01-22-2026, REMOVED INTERIM COMPLETION DATE

MAH-680-4.58

PIER 3 CROSSFRAME REMOVAL AND REPLACEMENT
BRIDGE NO. MAH-00680-04.886
OVER PRICE ROAD & MILL CREEK

NOTES:

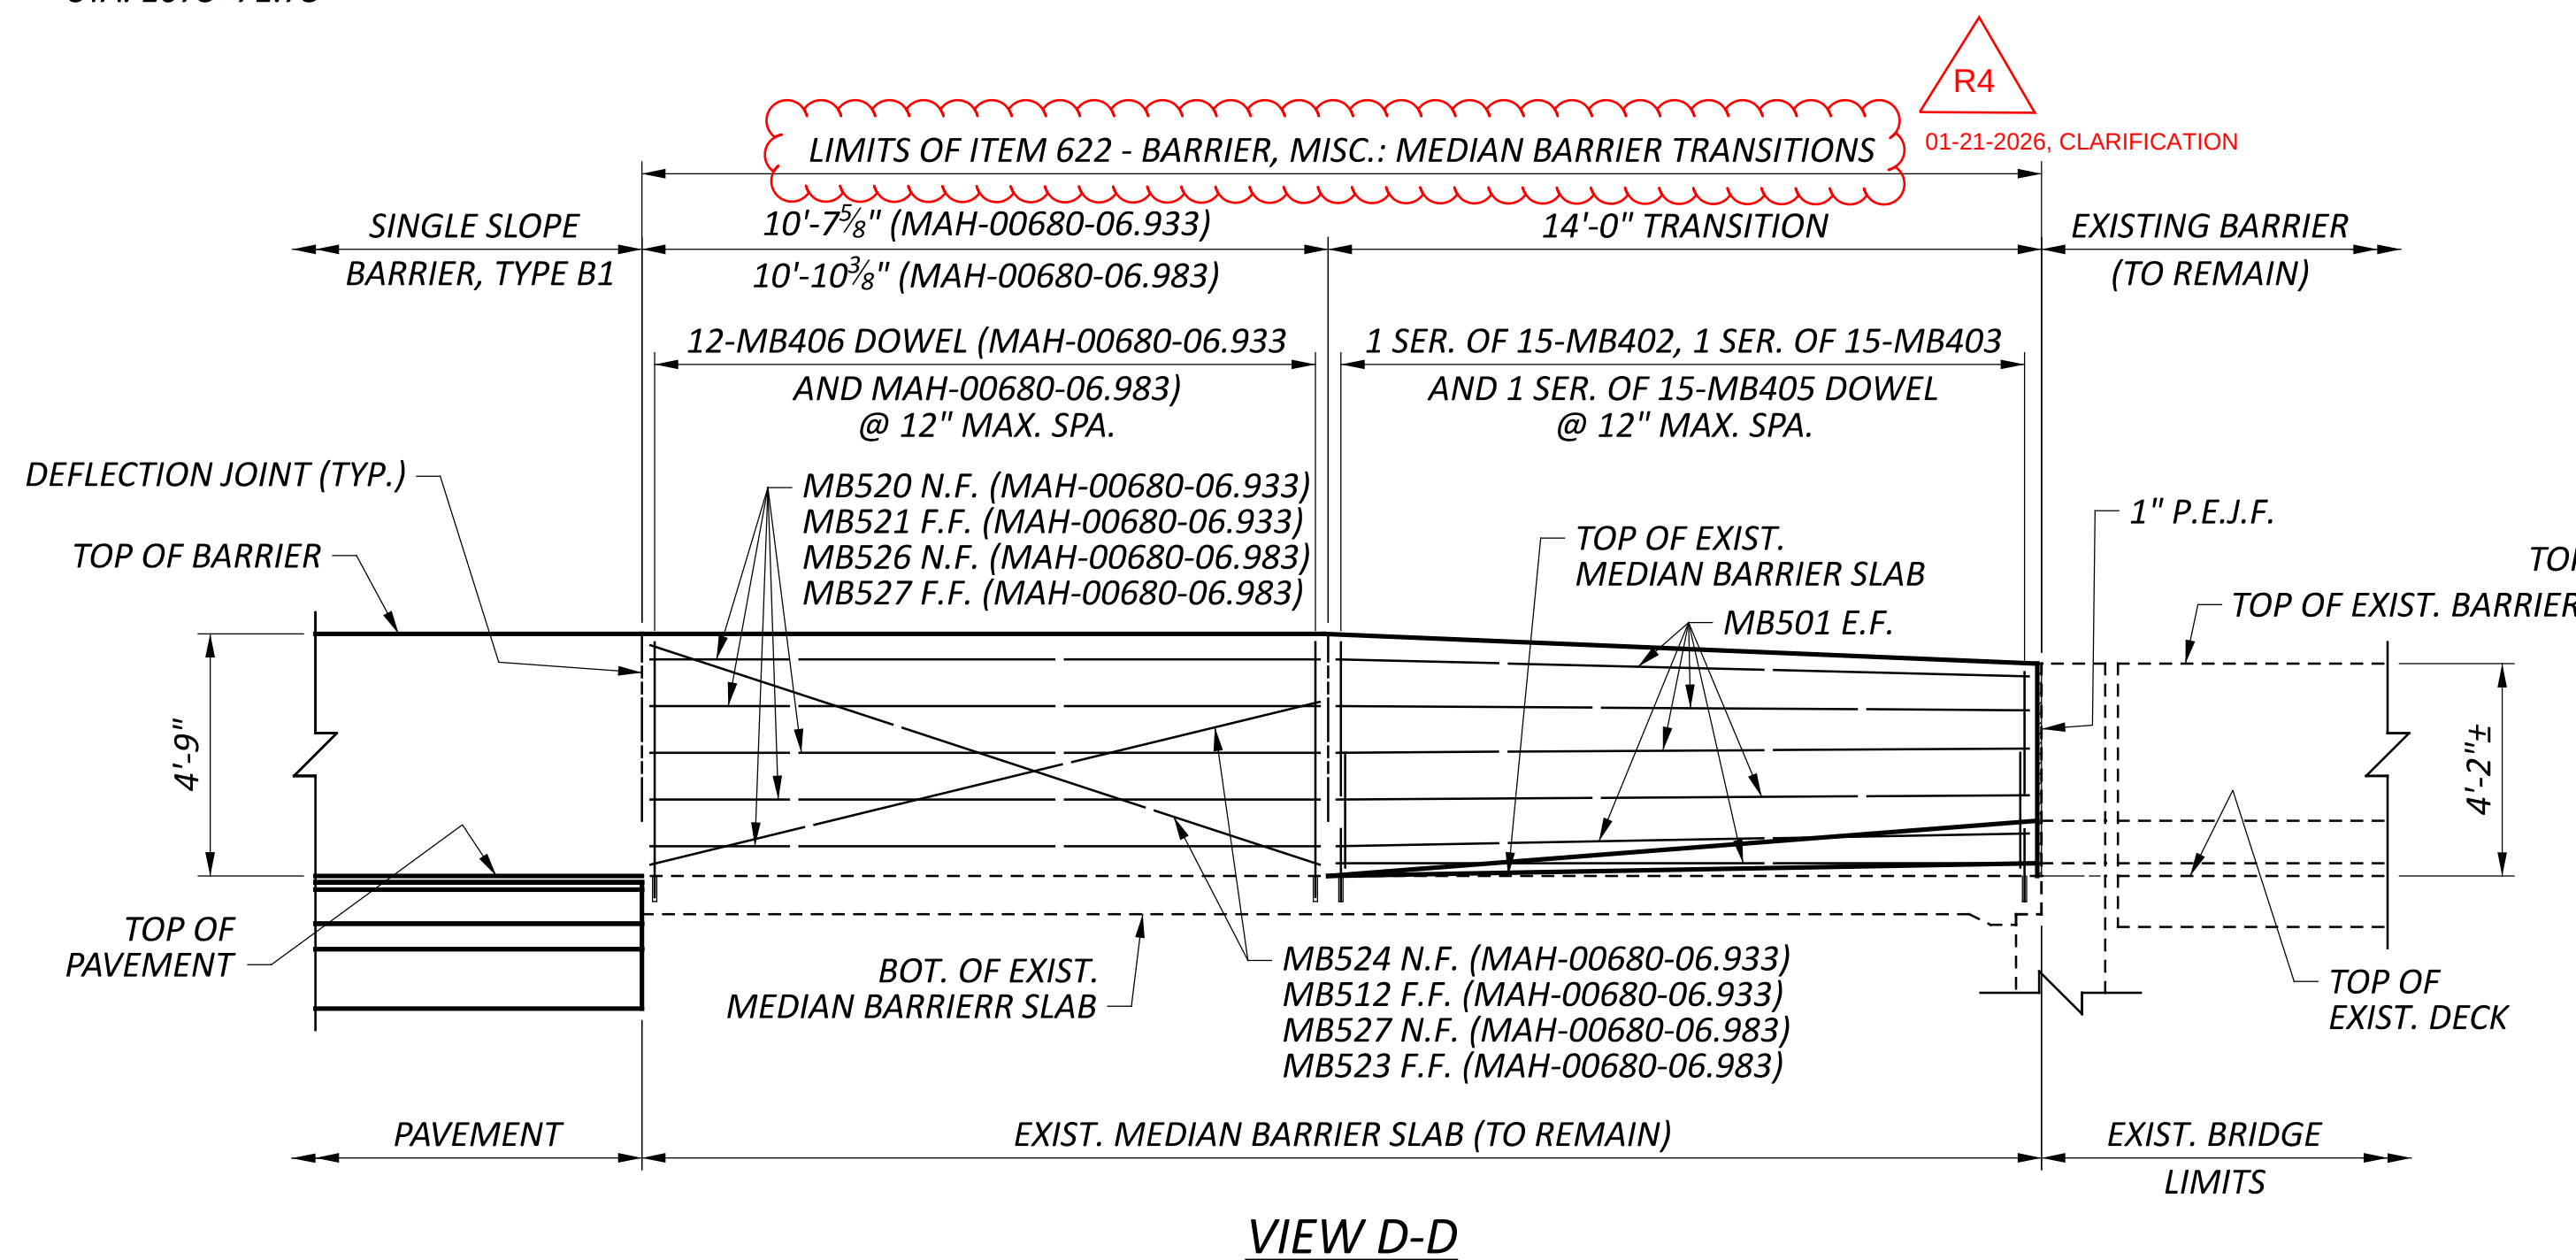
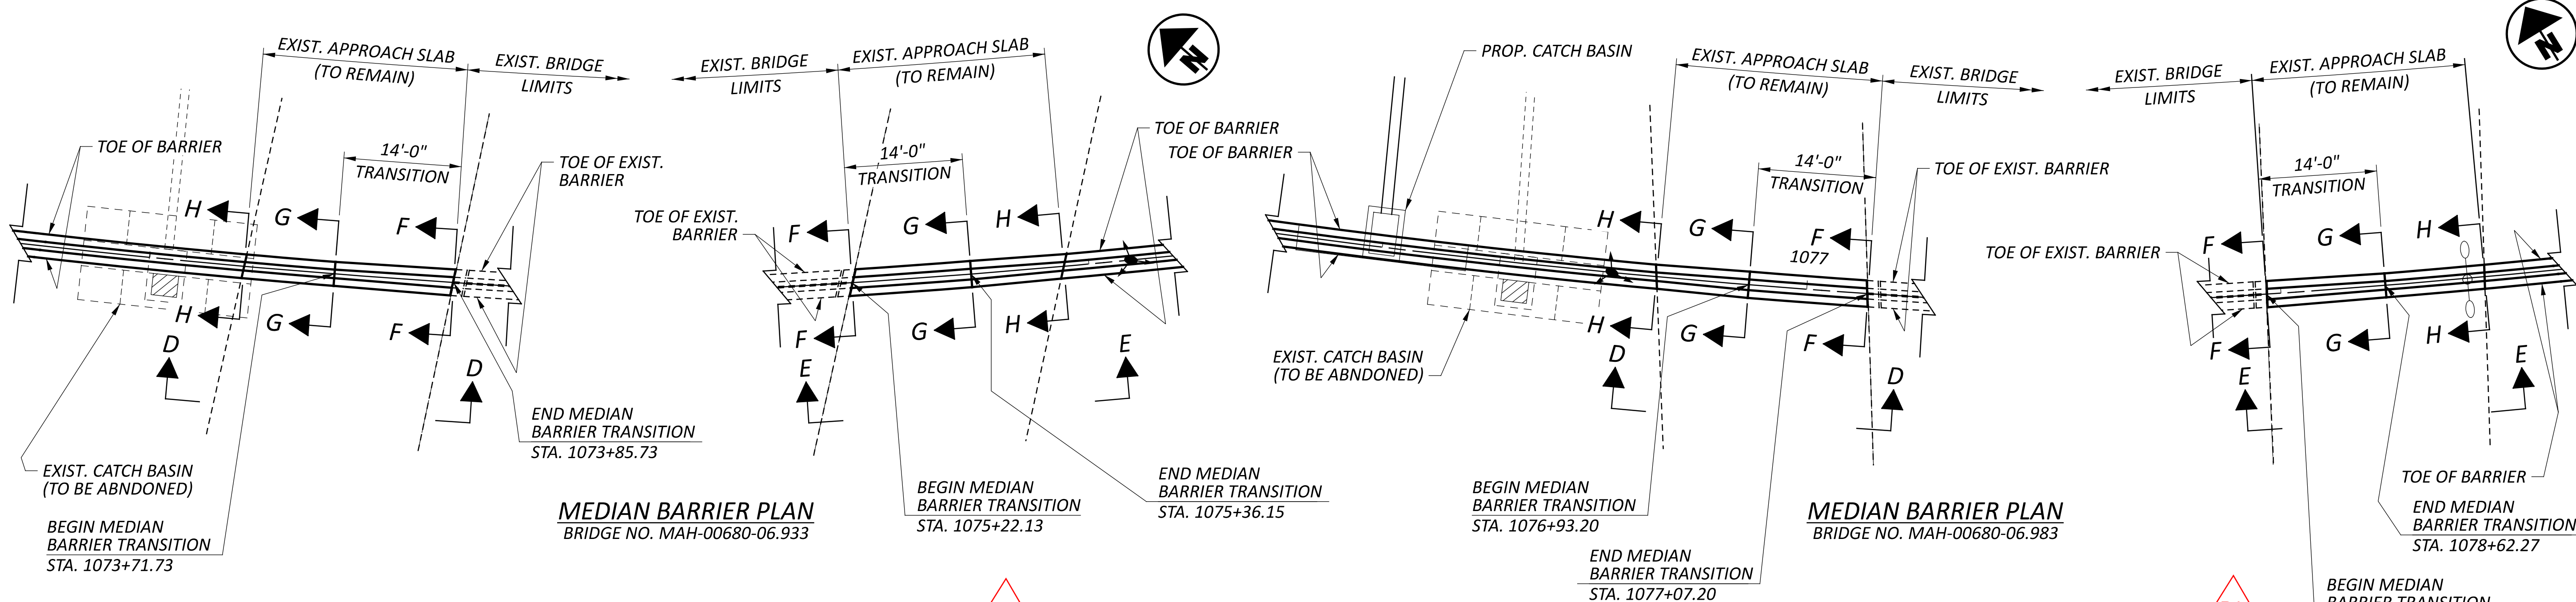
R4
 01-21-2026, CLARIFICATION

1. *FOR ADDITIONAL RAILING DETAILS, SEE STANDARD DRAWING SBR-2-20.*
2. *FOR REINFORCING STEEL LIST, SEE SHEET P.549/655.*
3. *PAYMENT FOR ALL LABOR, EQUIPMENT, MATERIALS AND INCIDENTALS NECESSARY TO FURNISH AND CONSTRUCT THE MEDIAN BARRIER TRANSITIONS SHALL BE INCLUDED WITH ITEM 622 - BARRIER, MISC.: MEDIAN BARRIER TRANSITIONS. REINFORCING STEEL, 1" P.E.J.F., CONCRETE, AND DOWELS SHALL BE INCIDENTAL TO THIS ITEM. A QUANTITY OF 110 FT HAS BEEN CARRIED TO THE GENERAL SUMMARY.*
